COMBUSTION ENGINEERING, INC.
WINDSOR NUCLEAR FUEL MANUFACTURING FACILITY
REQUEST FOR LICENSE AMENDMENT
DOCKET NO. 70-1100, LICENSE NO. SNM-1067
LIST OF AFFECTED PAGES

REQUEST FOR LICENSE AMENDMENT

COMBUSTION ENGINEERING, INC.
WINDSOR NUCLEAR FUEL MANUFACTURING FACILITY
REQUEST FOR LICENSE AMENDMENT
DOCKET NO. 70-1100, LICENSE NO. SNM-1067
PROPOSED CHANGE PAGES

FIGURE 8.14

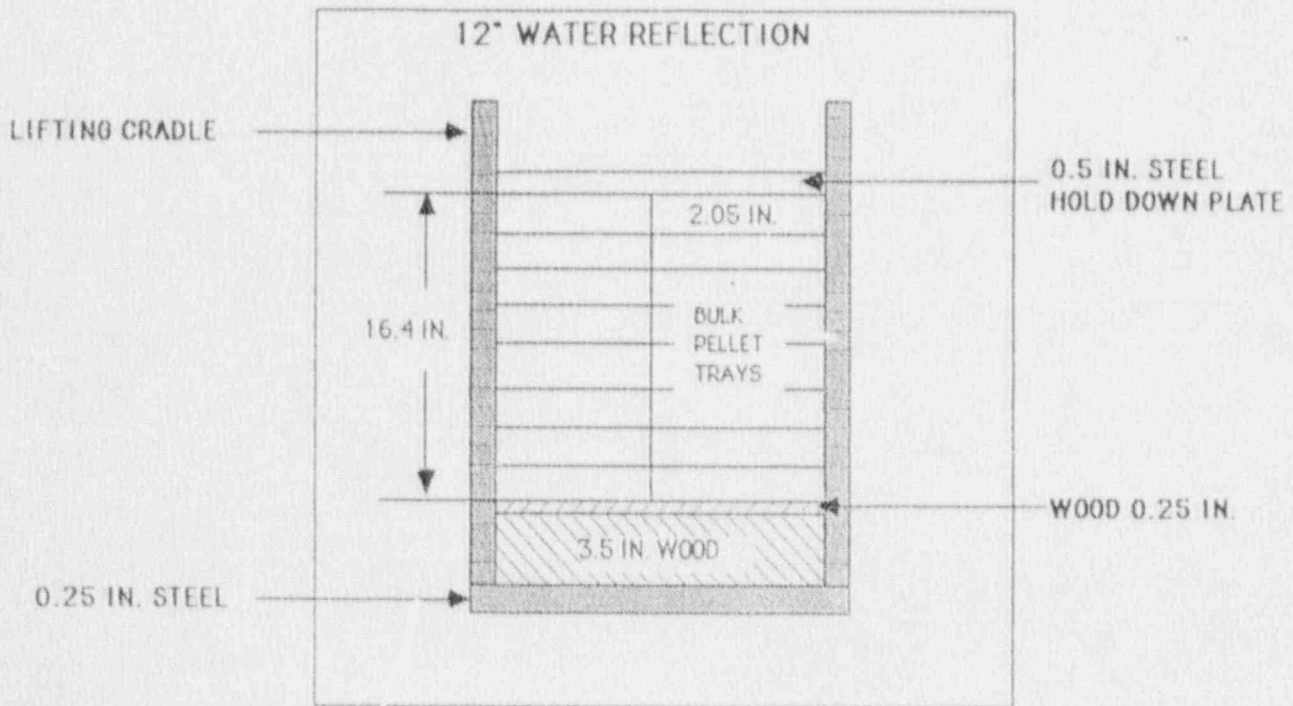
The cradle of pellet trays as it emerges from the vertical UNC-2901 shipping container does not meet the slab criteria of Chapter 4. Figure 8.14 shows the KENO-IV model of the UNC-2901 cradle with an 8x2x1 array of bulk pellet trays. The cradle and hold-down plate are represented but the compression hardware is neglected. The inner width of the cradle in the plane of Figure 8.14 is 10 inches. In the transverse direction, the cradle has a zero thickness and the wood block at the bottom of the cradle is 10.25" in width. A 0.38 inch thick slab of rubber above the 3.5 inch wood block is replaced by equivalent wood in the KENO-IV model. Each pellet tray pair is represented explicitly as a single tray having outer dimensions of 10" x 10 1/4" x 2.05". The interior

Double wall between each 5"x 10 1/4" pellet tray in the pair is neglected in the modelling. The corresponding internal dimensions of the trays are 9.844" wide by 10.094" long and 1.922" high. The width of 9.844" includes the two wall thicknesses that are represented as added free volume in the tray interior. The interior volume of the two trays is conserved in the computation of the water that the pellets are assumed to be immersed within for this conservative analysis.

The UO2 pellet volume is computed as the quotient of the pellet weight and an assumed effective pellet density of 10.25 g/cc. The free volume is the total volume of the eight double trays (25.04 liters) minus the volume of the UO2. The cradle is surrounded on all surfaces by a one foot thick water reflector.

A sixteen group cross section library was created using the NITAWL and XSDRNPM codes and the 123 group DLC-16 basic cross section library. The sixteen group energy structure is the same as in the Hansen and Roach 16 group library. The KENO-IV multiplication factors plus twice the KENO-IV standard deviation versus pellet tray loading are shown in Figure 8.15 over a range which extends below the minimum allowed shipping weight per tray, assuming the container was loaded with 16 trays each at the minimum loading.

An additional KENO-IV calculation was run for the case where there were 16 trays, each loaded with 6.2 Kg of pellets. In this analysis the cradle, hold-down plate, wood spacer block and 0.38 inch thick rubber slab are replaced by water. Thus, the 8x2x1 configuration of trays is reflected by a minimum of 12 inches of water on each side. This calculation yields a multiplication factor of 0.89576 ± 0.00508 or a $K_{eff} + 2 \text{ sigma}$ of 0.90592. It may be concluded from this analysis that the cradle structure reduces the adjusted multiplication factor by about 2% but, even in the absence of the structure, the 8x2x1 array of pellet trays is adequately subcritical so as to present no safety concern.
